**Addendum #3**

**T25-59 - HVAC Upgrades at Vaughan Willard  
Public School**

## MECHANICAL ADDENDUM NO. MADD-002

## STRUCTURAL ADDENDUM-No: SA-01

##### 1.0 S-201 – Key Plan, Part Low Roof and High Roof Framing Plans

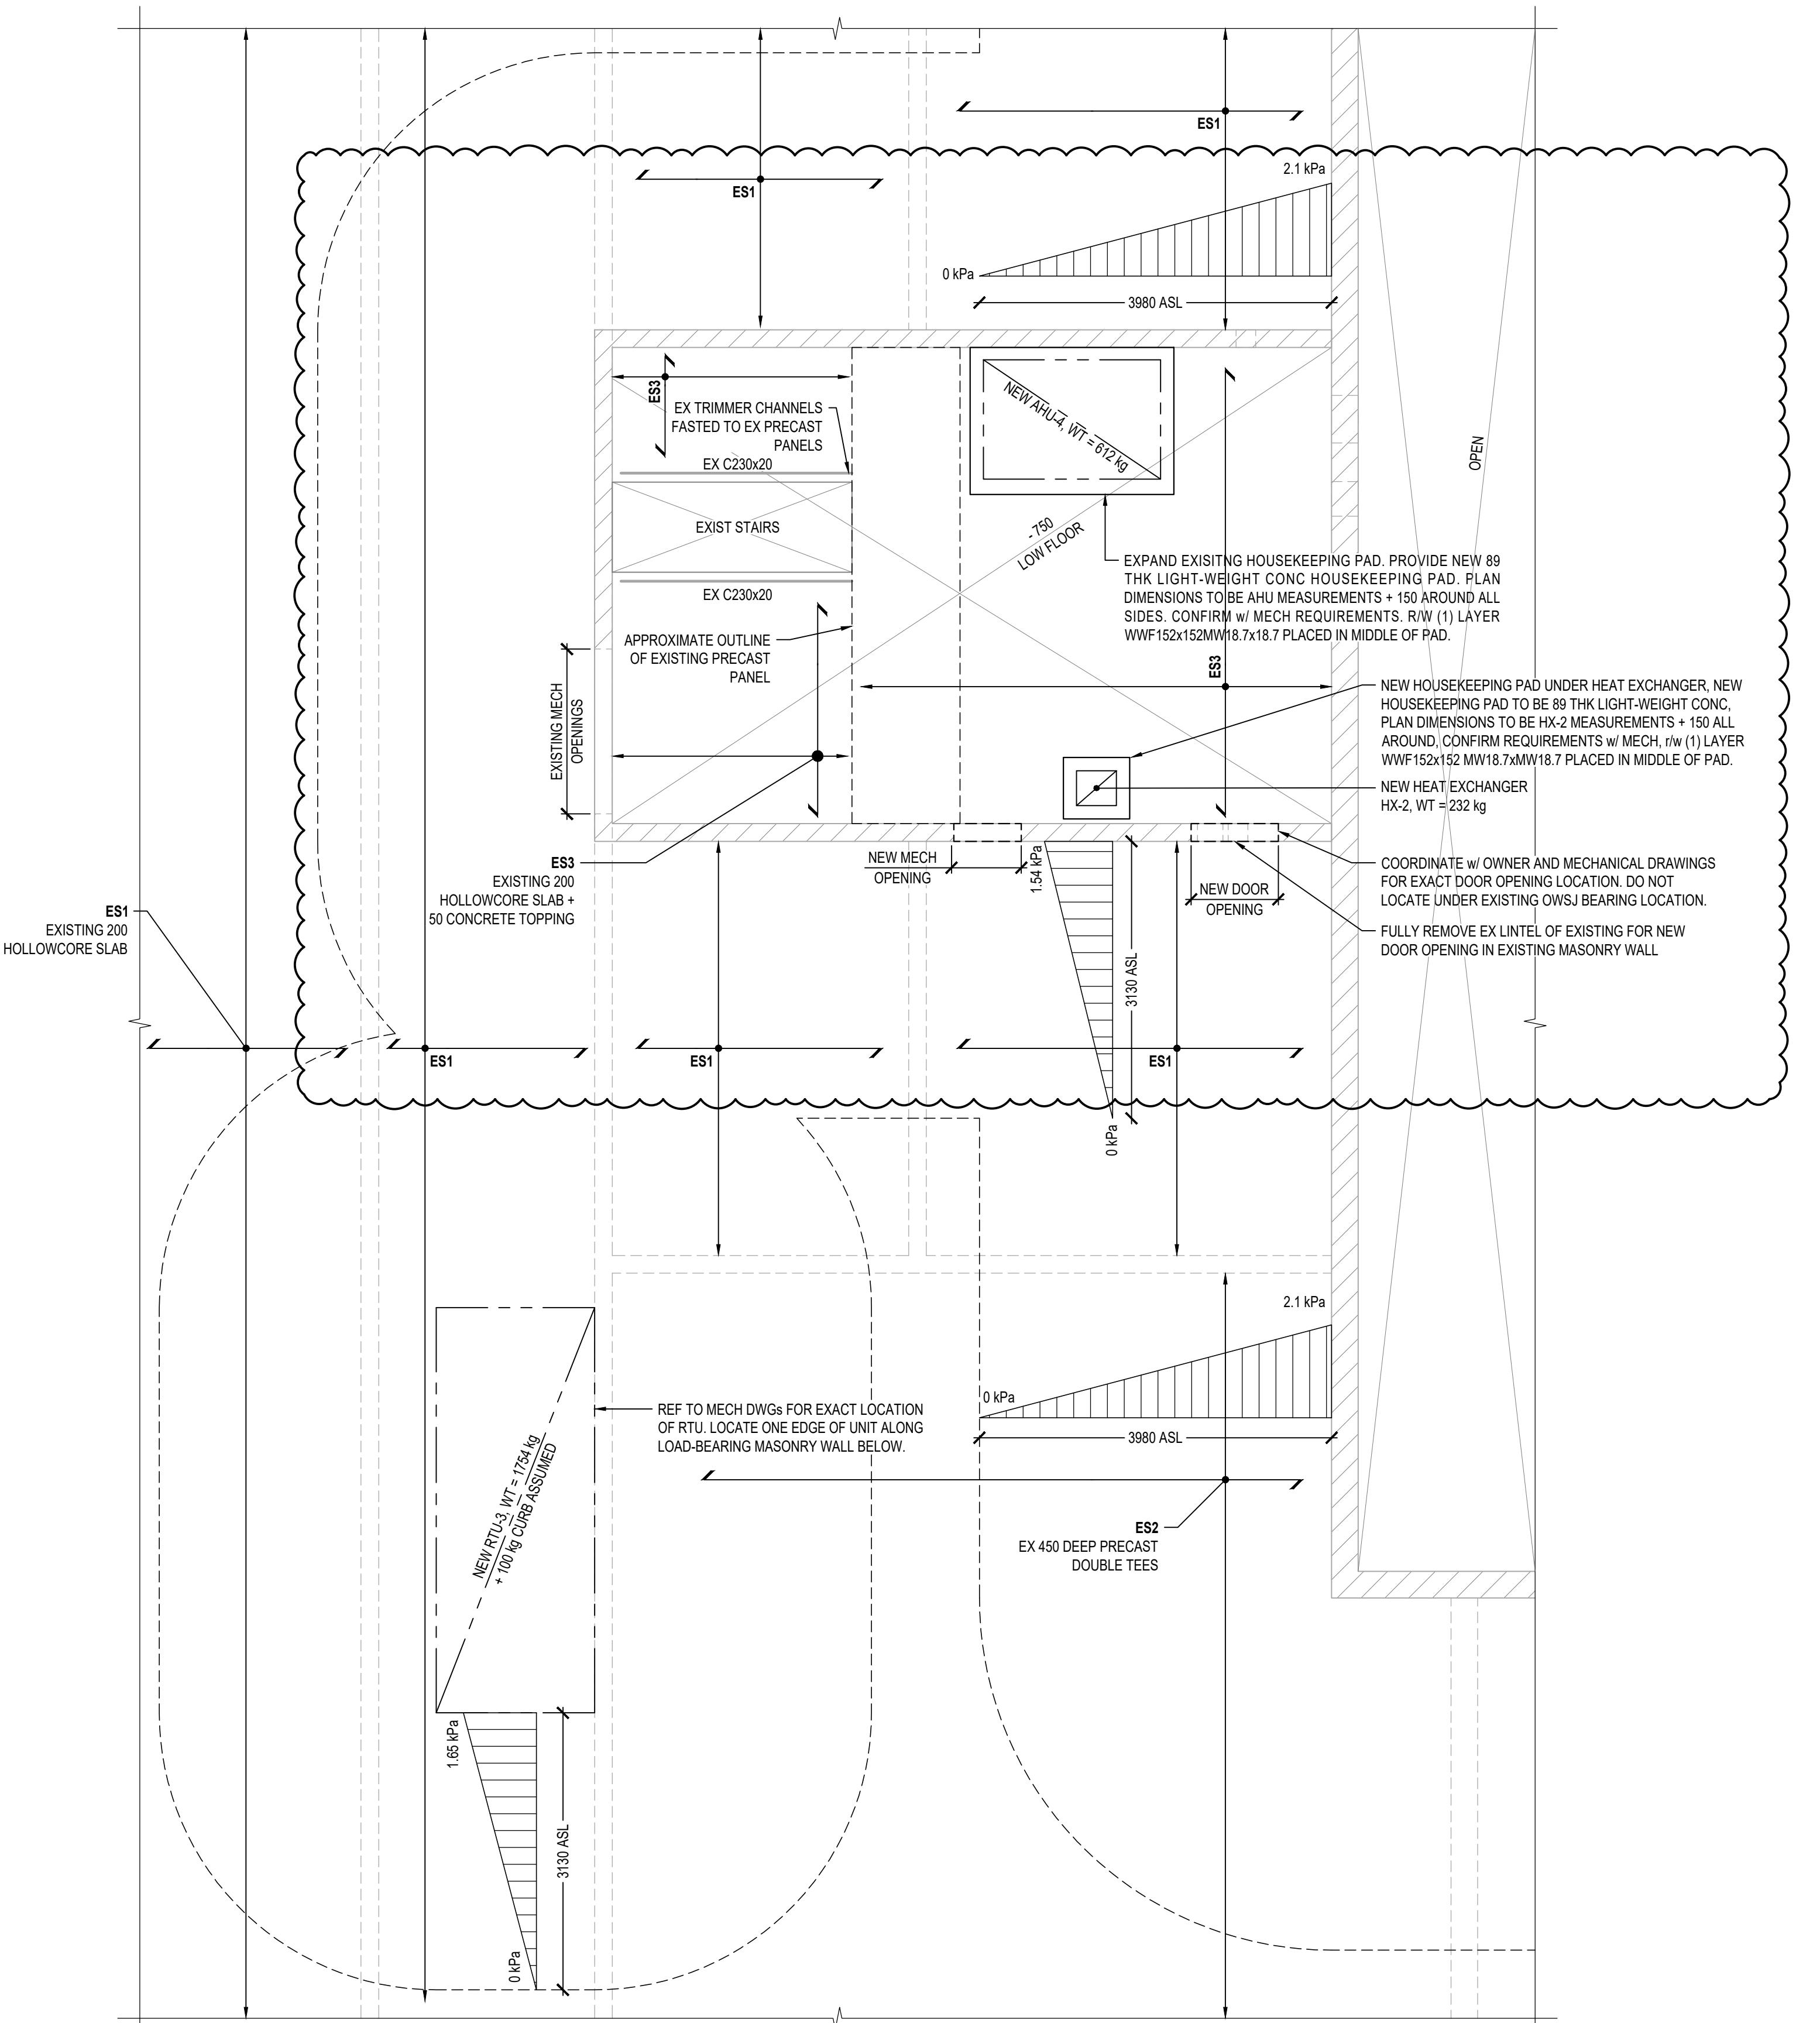
- 1.1 Update drawing title to reflect plans noted on contract documents.
- 1.2 *B/S-201 – Low Roof Framing Plan* – Revise documents to update locations of new and existing mechanical openings, as shown bubbled.
- 1.3 *C/S-201 – High Roof Framing Plan* – Revise documents to update locations of new and existing mechanical openings and lintel locations, as shown bubbled.
